PROJECT TITLE
CHATBURN ROAD
CLITHEROE

DRAWING TITLE
Fencing Layout
PLANNING ISSUE
DRAWING NUMBER
016/F/01

REVISION
E

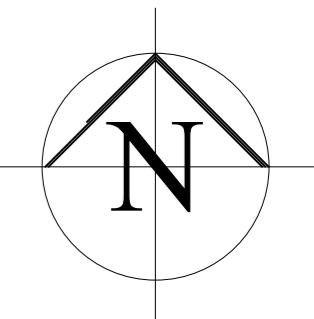
E	29/01/20	Retaining structures shown.Divisional taper fencing omitted.
D	03/12/19	Notation in key on fencing type amended and fencing to plots 1-9 amended
C	03/05/18	Notation in key on boundary type amended
B	03/05/18	Fencing plots 23-25 amended
A	30/04/18	Addition fence type indicated. Walls to plots 14 & 30 amended to suit Landscaping Layout
